RE: St. Lucie Units 1 and 2
Docket Nos. 50-335 and 50-389
Renewed Facility Operating Licenses DPR-67 and NPF-16
License Amendment Request to Remove the Site Area Map from the Technical Specifications

St. Lucie Nuclear Plant, Units 1 and 2
License Amendment Request to Remove Site Area Map from the Technical Specifications

**ST. LUCIE UNIT 1 AND ST. LUCIE UNIT 2
PROPOSED TECHNICAL SPECIFICATIONS PAGE (MARKUP)**

ST. LUCIE UNIT 1 AND ST. LUCIE UNIT 2
PROPOSED TECHNICAL SPECIFICATIONS PAGE (MARKUP)

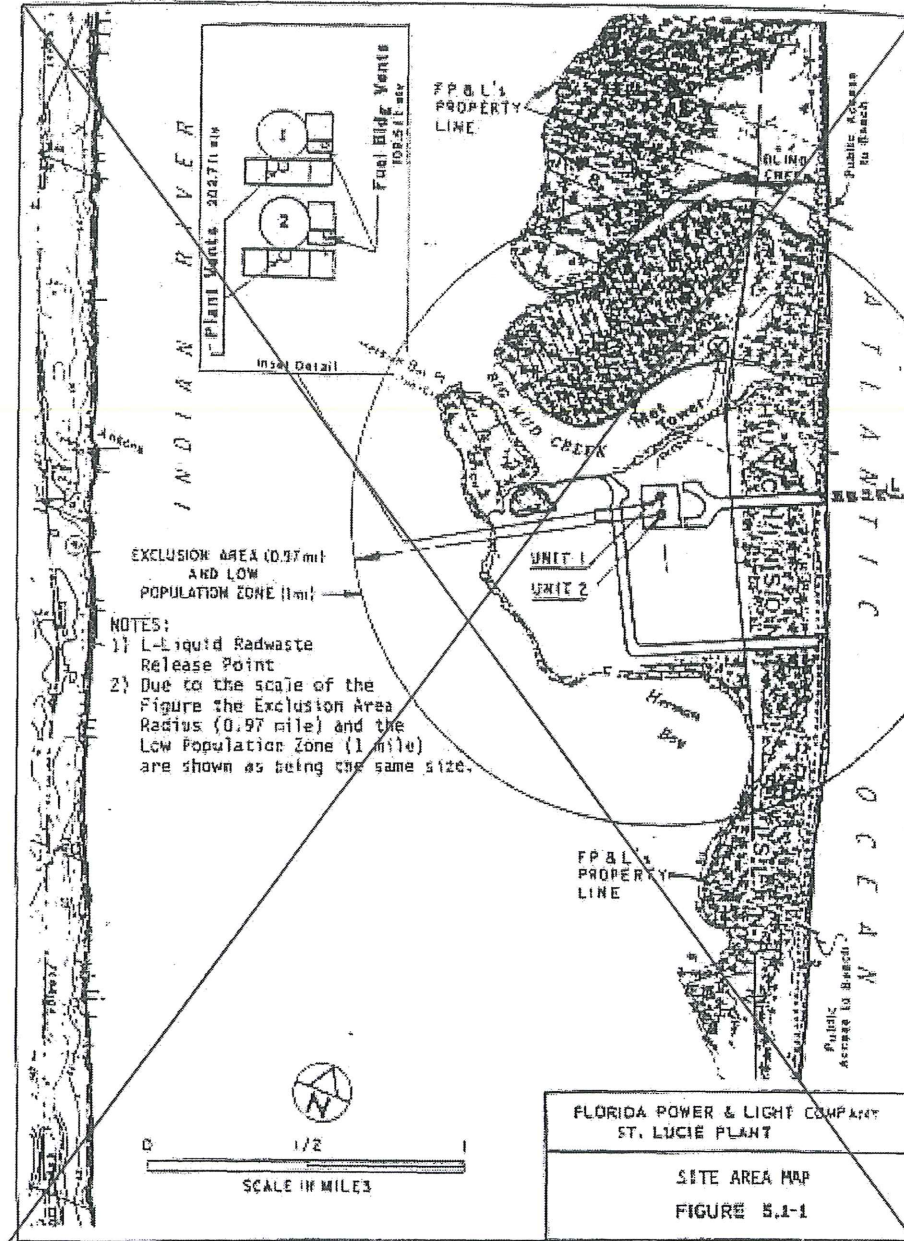
Florida Power & Light Company (FPL) requests amendments to Renewed Facility Operating Licenses DPR-67 for St. Lucie Nuclear Plant Unit 1 and NPF-16 for St. Lucie Nuclear Plant Unit 2. The proposed license amendments modify the St. Lucie Unit 1 and St. Lucie Unit 2 (St. Lucie) Technical Specifications (TS) by removing Figure 5.1-1, Site Area Map, removing TS references to Figure 5.1-1, and adding a site description.

- Deleting Figure 5.1-1, Site Area Map.
- Replacing TS 5.1.1, Exclusion Area, and TS 5.1.2, Low Population Zone, with a description of the St. Lucie site location.
- Deleting TS 5.8, Meteorological Tower Location.

Replace with "Figure 5.1-1 Deleted"

Figure 5.1-1 Deleted

ST. LUCIE UNIT 1 AND ST. LUCIE UNIT 2
PROPOSED TECHNICAL SPECIFICATIONS PAGE (MARKUP)

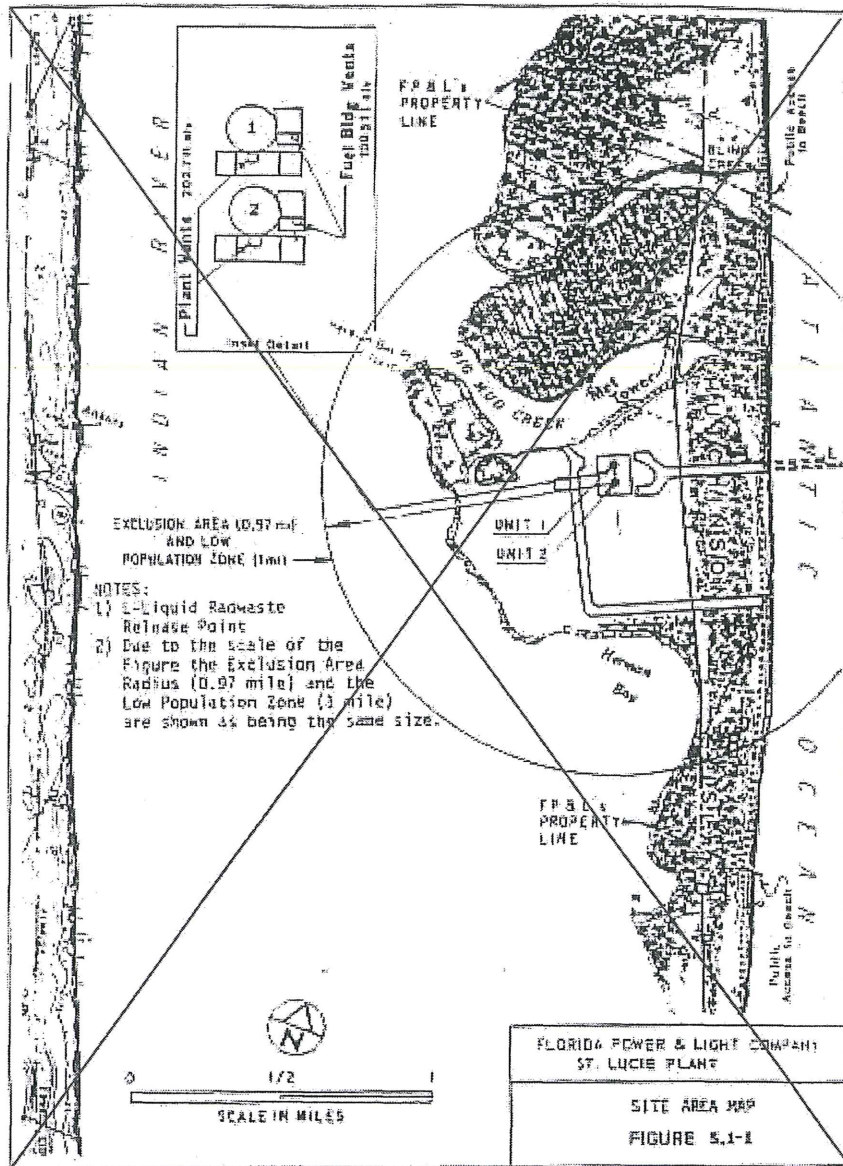
Replace with "Figure 5.1-1 Deleted"

Figure 5.1-1 Deleted
